REMARKS

ANNOTATED SHEET SHOWING CHANGES

Serial No.: 09/832,160

Docket No.: 2269-3846.2US

Fig. 6B

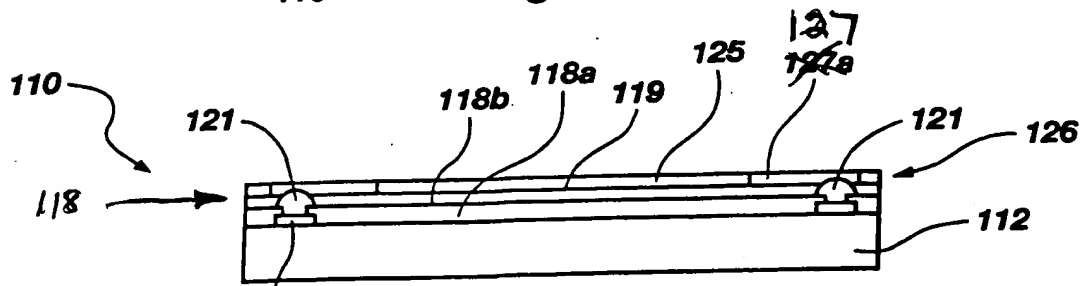
The attached sheets of drawings includes changes to Figs. 6B, 6C, and 8D. In each of Figs. 6B and 6C, reference character 118, which is mentioned in the specification, has been included with an appropriate lead line. In Fig. 6C, reference character 127a has also been replaced with reference character 127. In Fig. 8D, reference characters 218' and 222' have been replaced with reference characters 218 and 222, respectively.

Figs. 6B and 6C of the drawings have also been objected to under 37 C.F.R. § 1.84(p)(5) for failing to show reference character 118.

Appropriate corrections were made to these drawings by including reference character 118 and an appropriate lead line in each of Figs. 6B and 6C.
